SERVICE BULLETIN

DATE: 11 SEPTEMBER 1970

MODIFICATION FOR DOORS – OFF FLIGHT – CANOPY UPPER WINDSHIELD ASSEMBLIES, P/N 369A2405–3 AND 369A2405–4

Figure 1. Modification - Canopy Upper Windshield Assembly

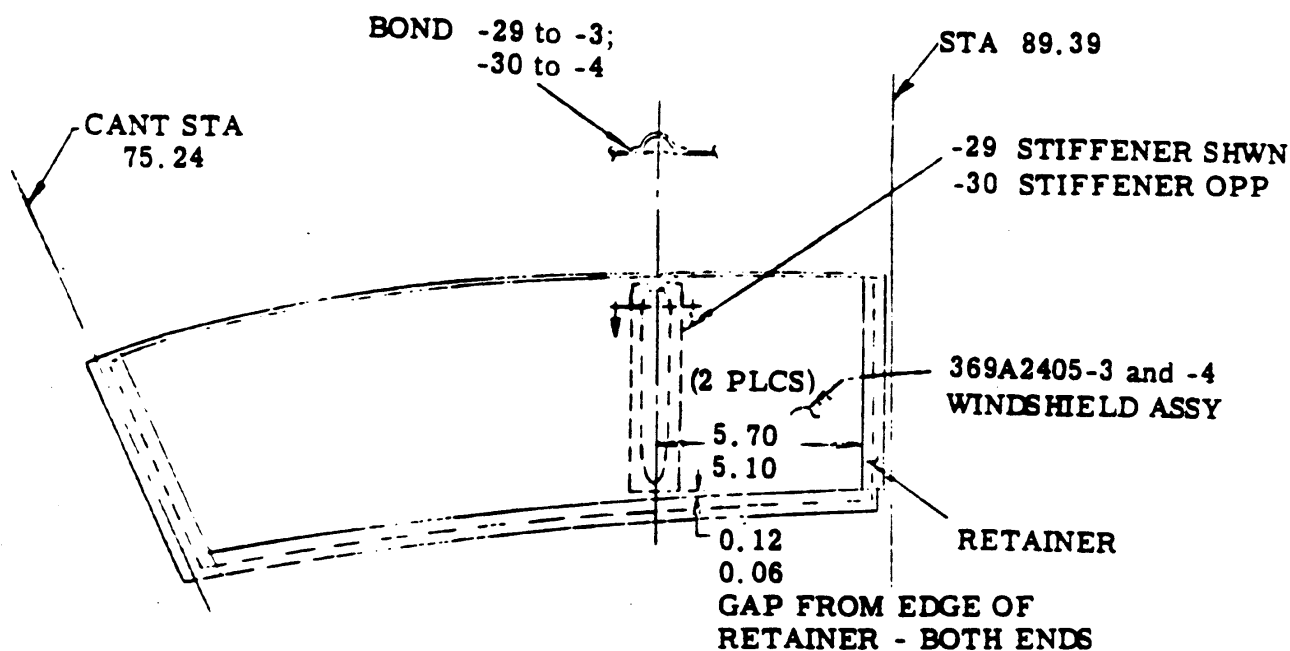
- a. Thoroughly clean faying surfaces of -29 and -30 acrylic stiffeners and inboard area of upper windshield assemblies; rub lightly with clean flannel cloth or equivalent dampened with aliphatic naphtha to remove all dirt, grease, etc. (See Figure 1 for bonding location and dimensions)
- b. Mask windshield areas adjacent to faying surfaces with masking tape. Large areas may be masked with cellophane sheet or Kraft paper held in place with masking tape or with strips of masking tape.

1. During bonding operation, cement should not be allowed to seep under edges of tape.
 2. Apply masking tape to within 1/8-inch of faying surface.
 3. If several strips of tape are used, overlap each strip approximately 1/2-inch.
- c. Prepare cement in accordance with manufacturer's instructions.
 - d. Apply mixed cement at one or both surfaces to be joined; immediately assemble stiffeners to windshield with contact pressure at dimensions shown in Figure 1.

- e. Apply light pressure on stiffeners to press out any air bubbles; remove any excess cement by scraping it onto masking tape, then remove tape.
- f. Secure stiffeners to windshields with masking tape; cure for 24 hours and remove masking tape.
- g. Check upper windshield assembly modification for discrepancies.
- h. Record compliance with this Service Information Notice in Compliance Record of helicopter Log Book.
